Intersection ID: 23232	Main Street: PARK_RD	Cross Street: QUAIL_HILL_RD	Location:	SW
ADA ID: 54E7C7985C17	Ramp Type: PerpDiag	Initial Pass/Fail: Fail	Overall Compliance: No	Severity Score: 13.75

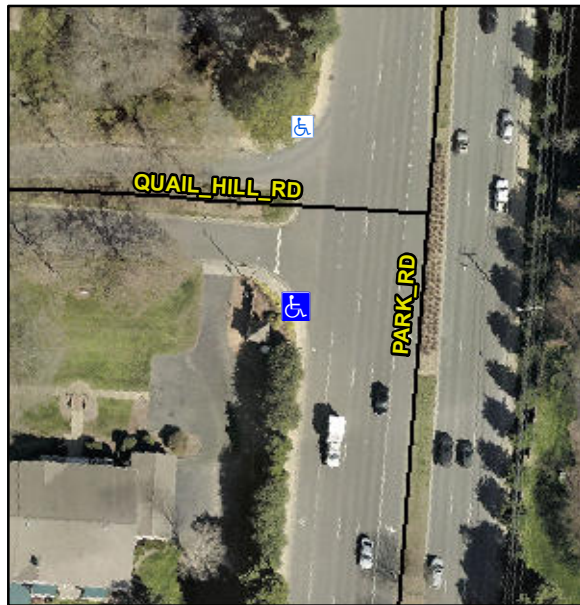
R304.2.2, R304.5.3

Compliance	Description	Data	Compliance	Description	Data
N/A	Ramp Length (in)	59.0	No	Ramp Slope (%)	8.4
Yes	Ramp Width (in)	48.0	No	Ramp XSlope (%)	2.7
N/A	Flare Type LT	N/A	N/A	Flare Type RT	N/A
N/A	Flare Slope LT (%)	N/A	N/A	Flare Slope RT (%)	N/A
N/A	Flare Traversable LT?	N/A	N/A	Flare Traversable RT?	N/A
N/A	Landing Length (in)	N/A	N/A	DWS Provided?	N/A
N/A	Landing Width (in)	N/A	N/A	DWS Contrast?	N/A
N/A	Landing Slope (%)	N/A	N/A	DWS Length (in)	N/A
N/A	Landing X Slope (%)	N/A	N/A	DWS Full Width?	N/A
N/A	Landing Curb? (Y/N)	N/A	N/A	DWS Offset (in)	N/A
N/A	Shared Landing?	N/A			
N/A	Gutter Ponding?	N/A	N/A	Gutter Slope (%)	N/A
N/A	Gutter Lip Ht (in)	N/A	N/A	Gutter X Slope (%)	N/A
N/A	Painted X Walk1?	No	N/A	Painted X Walk2?	No
	X Walk 1 Direction	To SE		X Walk 2 Direction	To NE
N/A	X Walk 1 Width (in)	N/A	N/A	X Walk 2 Width (in)	N/A
	X Walk 1 Slope (%)	5.5		X Walk 2 Slope (%)	2.4
	X Walk 1 X Slope (%)	3.7		X Walk 2 X Slope (%)	2.3

Remove & Replace Curb Ramp With Two New Directional Ramps or Equivalent.
